SERVICE BULLETIN

SERVICE BULLETIN		No.: MSB-99E11-503e	
		Date: 1999-07-15	
Subject: OMISSION OF INJECTION TIMING IDENTIFICATION MARK		<Model> ALL MODELS	<M/Y> 99-10
Group: ENGINE		Draft No.: 99EN511109	
CORRECTION	OVERSEAS SERVICE DEPT	 T. NITTA - VICE GENERAL MANAGER QUALITY INFORMATION ANALYSIS

Omission of the injection timing identification mark has been rectified.

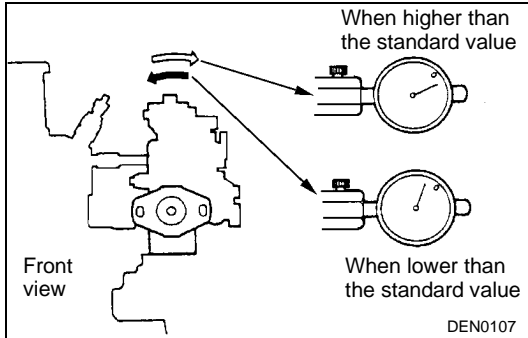
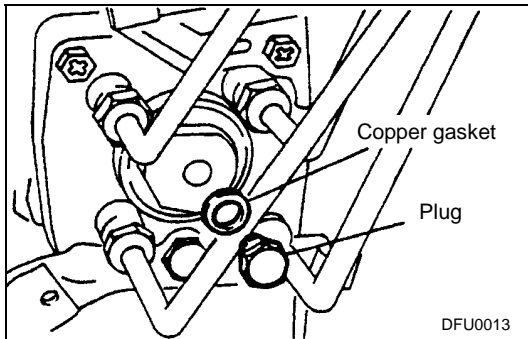
The injection timing can be known from the identification mark stamped on the cylinder head at the position shown in the illustration.

Identification mark	Injection timing
A or B	7° ATDC
C or D	9° ATDC

Or E <Added>
